SB-10055306-6071

Seat Harness Routing (Swivel)
 VAH, VHD, VN

FSB 375-011, Seat Harness Routing (Swivel)

(March 2014)

W3088667

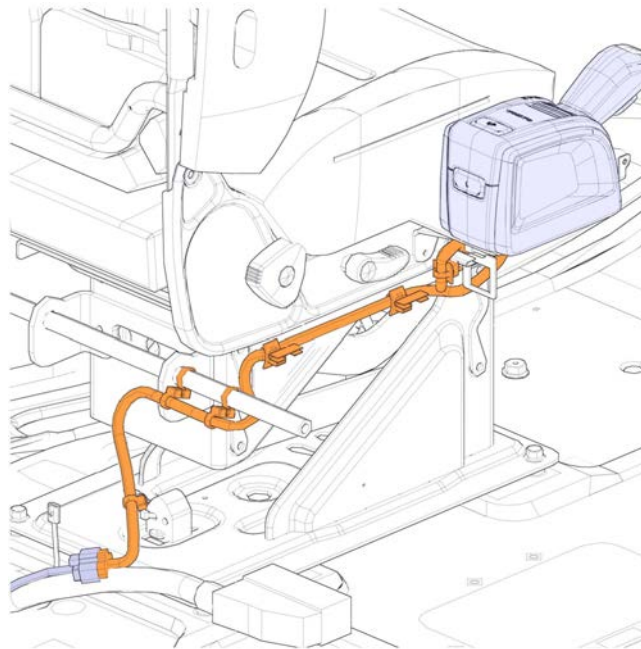
- 5 Loosely install and cable tie along the new path for routing and clipping.

Note: Do not tighten cable ties fully at this time.

Correct Routing
Cable Tie with Horizontal Edge Clip # 21096682, Qty 2

W3076416

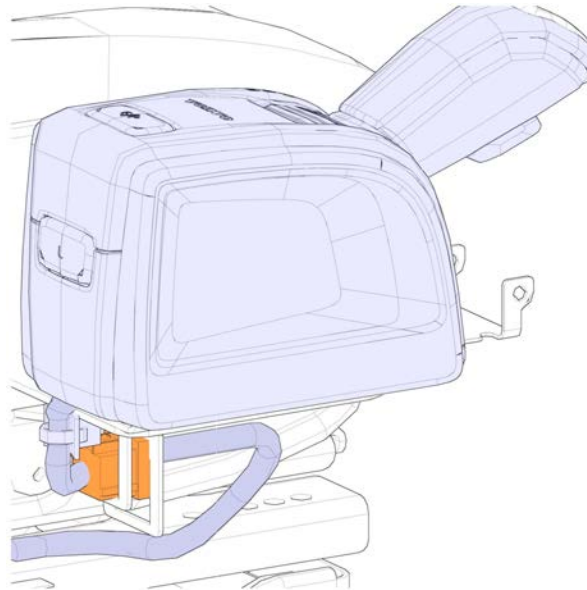
Note: The strain relief loop going to shifter will have increased in length with new routing and clipping method, to ensure no strain on wiring harness or shifter connector with seat in swivel position.
